Memorandum

*Subject: Watershed Delineation Rezoning Review – Gravel Pit Parcel
Lake Auburn Watershed Protection Commission*

Figure ES-1: Summary of Estimated Watershed Boundary Review

Figure 12 Study area monitoring wells and zoning

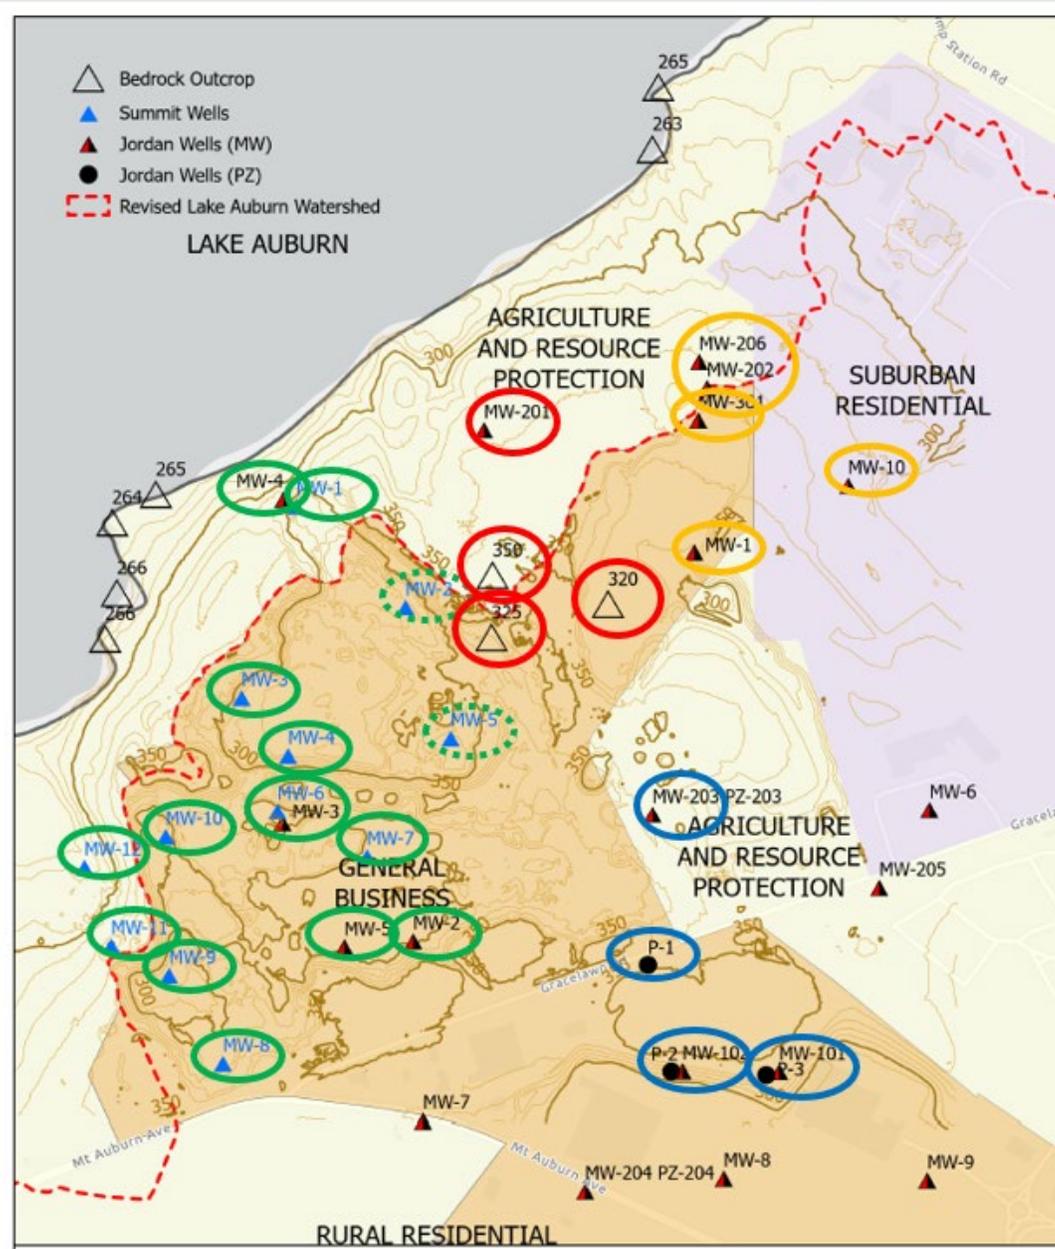
Near the center of the area where the watershed delineation has been revised (study area), the bedrock surface rises, creating what is called a bedrock "knob". Groundwater flow here occurs only in bedrock. The bedrock groundwater level well MW-201 in this subarea is more than 40 feet above the lake surface water level and the groundwater level could be higher still near the bedrock outcrops farther to the south. Well MW-201 and the outcrops are circled in red in **Figure 12**.

To the west and southwest of the bedrock knob is a subarea represented by 14 monitoring wells (solid green circles in **Figure 12**) where the overburden groundwater level measurements are consistently below the lake surface water level. Groundwater in the area represented by these wells does not discharge to the lake. This is consistent with the revised watershed delineation, except that two of the wells in this group are north of the revised watershed delineation as shown in **Figure 12**.

Summit Environmental well MW-2 and MW-5 (Dashed green circles in **Figure 12**) are likely near the limit of the west-southwest subarea where groundwater flow is predictably away from the lake. Just to the northeast of these wells the ground surface and bedrock surface rise steeply towards the knob area.

The previous watershed delineation apparently included the Gracelawn Landfill near its southeastern limit. Groundwater level and water quality data at wells circled in blue in **Figure 12** indicate that groundwater flow in this vicinity is southward, away from the lake. This is consistent with the revised watershed delineation.

Groundwater in the area indicated by the orange circled wells east of the knob in **Figure 12** likely flows in part to Lake Auburn and in part to a small stream just east of the study area that is ultimately tributary to the Androscoggin River. Data in the review documents, are not sufficient to precisely locate the divide between groundwater flow to the lake and to the river, and thereby establish a precise watershed boundary.

There are insufficient data to reliably determine bedrock aquifer flow directions, but it would be reasonable to extend the revised watershed farther south in this area, to at least include the observed outcrop areas where the bedrock aquifer would be directly recharged as well as the nearby topographic high.
